16 Avenue N. and 19 Street E. Interchange Functional Planning Study

Phase 2 Stakeholder Input Summary

Option A: Diamond Interchange at 19 Street NE

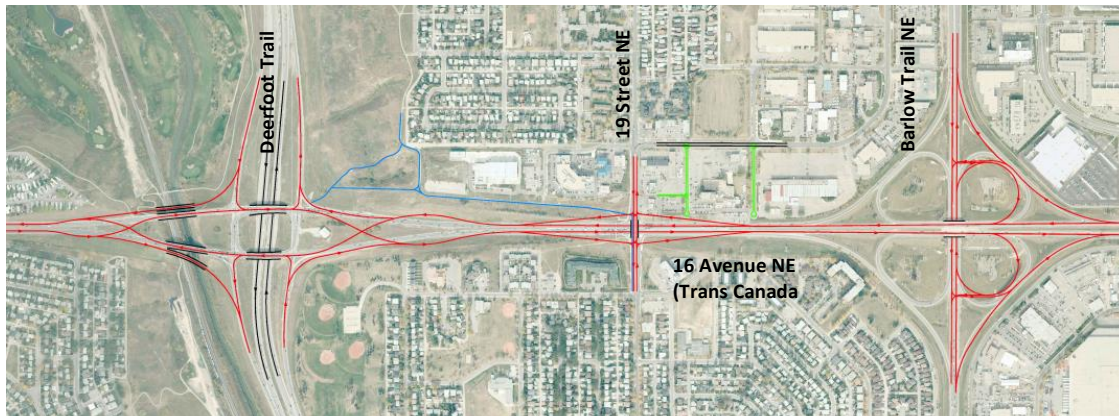
Strengths	Weaknesses	Proposed Changes
<ul style="list-style-type: none"> - Ramps at Barlow Trail will improve weaving distance (3) - Increases traffic flow on Deerfoot Trail (2) - May reduce noise for adjacent residents and businesses (2) - Adequate time to make connector change off 16 Avenue - Accommodates cyclists - Good for unfamiliar motorists - Reduces traffic on Barlow Trail - Economical - Free-flow traffic on 16 Avenue deters motorists from shortcutting through Mayland Heights - The Diamond Interchange at 19 Street provides all movements - Eliminates weaving at 19 Street - Reduces traffic on 19 Street - Folded Partial Cloverleaf at Barlow Trail - Turning flyovers northbound/southbound on 16 Avenue 	<ul style="list-style-type: none"> - Diverging Diamond Interchange is complex (3) and unfamiliar to Calgary drivers (3) - Disconcerting to see headlights from oncoming traffic when driving eastbound on 16 Avenue (from Diverging Diamond Interchange) - Does not improve shortcutting traffic on 19 Street to 8 Avenue and through Mayland Heights - Excessive Traffic on 19 Street - Shell gas station will need to be removed - Overpass connects to pathway and access must be updated and maintained - Diamond Interchange at 19 Street is very tight - Folded Partial Cloverleaf at Barlow Trail will have capacity problems with conflicting traffic movements - Merging lanes on Barlow Trail are very tight - Not enough space between interchanges on 19 Street and Barlow Trail 	<ul style="list-style-type: none"> - Add roundabouts on 19 Street - Improve traffic on Deerfoot Trail to remedy 8 Avenue shortcutting - Add signals after the Diverging Diamond Interchange at Deerfoot Trail - Consider replacing the "Folded Parclo" at Barlow with a "Split Diamond"

Option C: Diamond Interchange at 19 Street NE

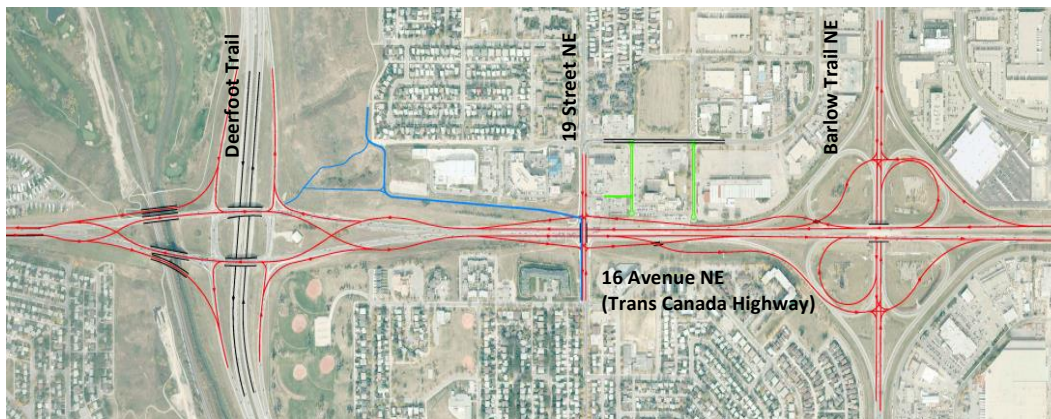
Strengths	Weaknesses	Proposed Changes
<ul style="list-style-type: none"> - Free-flow traffic on 16 Avenue - Accommodates cyclists - Surplus land at Barlow Trail (NW and SE quadrants) - Reduces shortcutting traffic on 19 Street - Limited movements reduce traffic on 19 Street - Weaving traffic works well - Diverging Diamond Interchange at Deerfoot Trail improves traffic - Basket weave structures at Barlow Trail improve weaving 	<ul style="list-style-type: none"> - Restricted access between Barlow Trail and 19 Street (3) - Motorists need to select destinations early - Not using existing infrastructure at Barlow Trail - Infrastructure costs associated with basket weave structures for Partial Cloverleaf "A" at Barlow Trail - Potential impact to green space and businesses - Diverging Diamond Interchange at Deerfoot Trail may be confusing to motorists and cyclists - Diamond Interchange at 19 Street is very tight - Not all movements provided 	<ul style="list-style-type: none"> - Need safe cyclist crossings - A lower "around the block" residential loop in the NW quadrant of 19 Street and 16 Avenue to eliminate weaving - Consider 3rd level at Deerfoot (D) instead of the diverging diamond

Option D: Split Diamond Interchanges at 19 Street and Barlow Trail

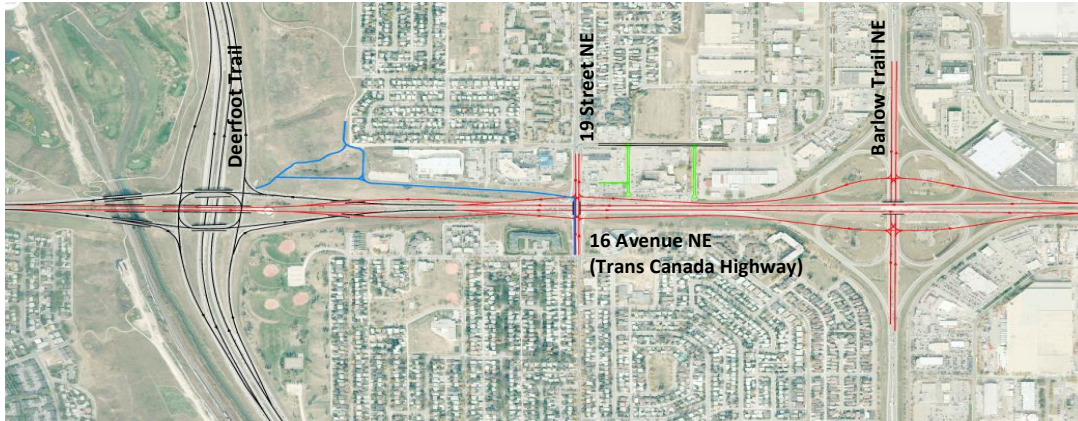
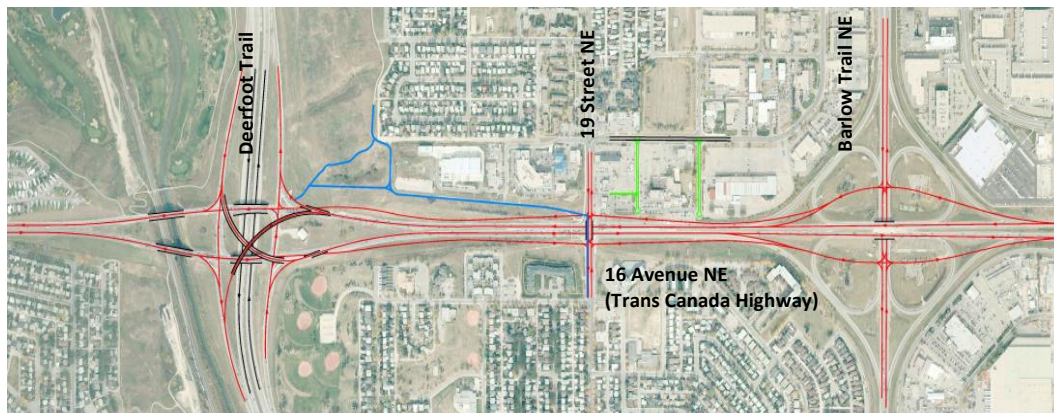
Strengths	Weaknesses	Proposed Changes
<ul style="list-style-type: none"> - Easier to navigate and less weaving (2) - Third level over Deerfoot Trail Interchange makes 16 Avenue from the west free-flow (2) and eliminates that traffic from the turning movements - Collector roads at 19 Street keep 16 Avenue traffic separated (2) - All movements are provided at 19 Street and at Barlow Trail (2) - Collector road reduces speed on 16 Ave (2) - Free-flow traffic on 16 Avenue (2) and Deerfoot Trail - Separation for cyclists - More access to 19 Street from Barlow Trail - Less traffic at 16 Avenue and Deerfoot Trail interchange - Through movements at Deerfoot Trail (northbound/southbound and eastbound/westbound) are physically separated 	<ul style="list-style-type: none"> - Large and costly infrastructure (3) - Connected/Split Diamond Interchanges at 19 Street and Barlow Trail require motorists to choose destinations very early; may be confusing (3) - Lacks free-flow on 16 Avenue at Deerfoot Trail from the east - Increases congestion at Barlow Trail because of motorists trying to access 19 Street - Third level interchange at Deerfoot Trail creates short weaving section for motorists between 19 Street and Deerfoot Trail - Increases travel time between Deerfoot Trail and 19 Street - Split Diamond Interchange at 19 Street is very tight and does not reduce short cutting - Split Diamond Interchange at Barlow Trail does not provide easy access between 16 Ave and Barlow Trail - Heavy eastbound left turn traffic demand at Barlow Trail will cause capacity issues at south intersection 	<ul style="list-style-type: none"> - Consider adding a directional loop ramp for eastbound to northbound traffic at Barlow Trail

Option J: Diamond Interchange with Collector-Distributor System

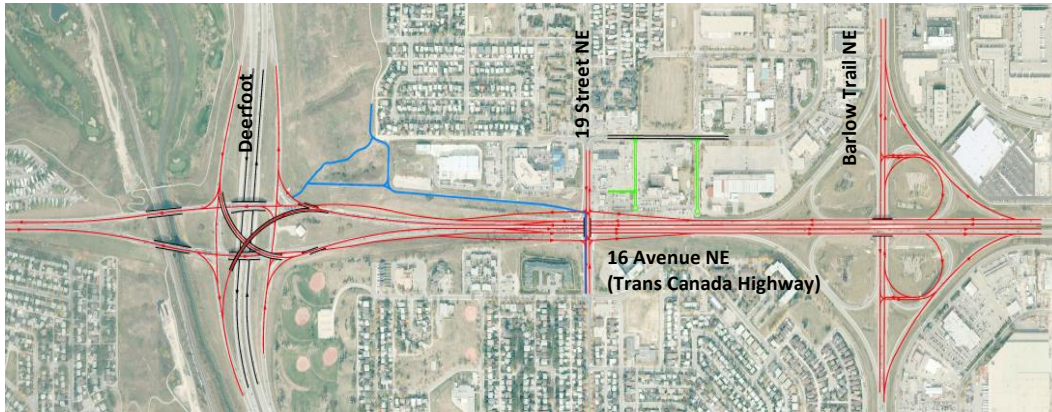
Strengths	Weaknesses	Proposed Changes
<ul style="list-style-type: none"> - Removes heavy left turn movements from 16 Avenue and Deerfoot Trail interchange (2) - Folded Partial Cloverleaf at Barlow Trail increases weaving distances (2) - Could solve weaving at Deerfoot Trail - Collector roads are forgiving – way finding? - New structure at Deerfoot Trail allows for pedestrian facilities - Directional ramps at Deerfoot Trail provide good connectivity between skeletal roads - Diamond Interchange at 19 Street provides all movements - Reduces congestion between Deerfoot Trail and 19 Street 	<ul style="list-style-type: none"> - Confusing (3) - Infrastructure cost (2) - Property impacts at 19 Street (2) - Large cross-section - Deerfoot Trail traffic will need to exit prior to directional ramps to access collector roads - Diamond Interchange at 19 Street is very tight - Folded Partial Cloverleaf at Barlow Trail will have capacity problems with all the conflicting traffic movements 	<ul style="list-style-type: none"> - Consider adding a third level over 16 Avenue if it would maintain through movement on 19 Street

Option O: Partial Diamond Interchange at 19 Street NE (1986 Option)

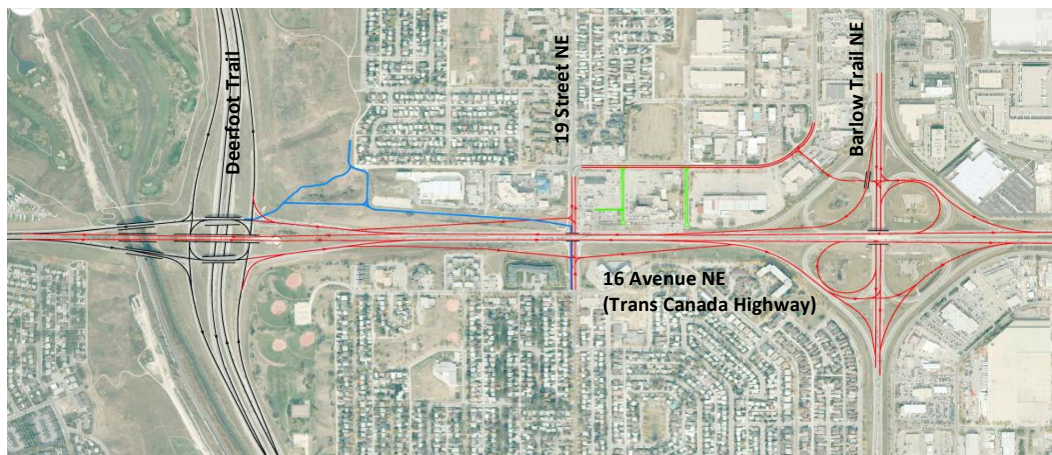
Strengths	Weaknesses	Proposed Changes
<ul style="list-style-type: none"> - Indirect routes and Partial Diamond Interchange at 19 Street could reduce short cutting through Mayland Heights (2) - Free flow traffic on Deerfoot Trail reduces traffic and is easy to understand - All through movements are separated, and Partial Cloverleaf "A" at Barlow Trail provides most movements 	<ul style="list-style-type: none"> - Increases traffic in school zone on 18 Avenue (3) - Third level at Deerfoot Trail creates weaving for eastbound traffic to 19 Street (2) - Confusing - Signing for cyclists to connect to existing pathway difficult - Difficult to go south on 19 Street from westbound 20 Ave - Tunnel or underpass between communities is not desired - Concerned with 16 Avenue bridge icing during the winter months - Shortcutting through Mayland Heights from Deerfoot Trail - No access from 16 Avenue for businesses on 19 Street - Infrastructure cost - Partial Diamond at 19 Street is tight and restricts movements and accessibility - Partial Cloverleaf "A" at Barlow Trail will impact businesses 	<ul style="list-style-type: none"> - Requires a pedestrian crossing - Remove businesses to build ramp from Barlow Trail to 18 Avenue to improve connectivity to 19 Street - Create a separate design for 19 Street that separates overpass from pedestrians and cyclists
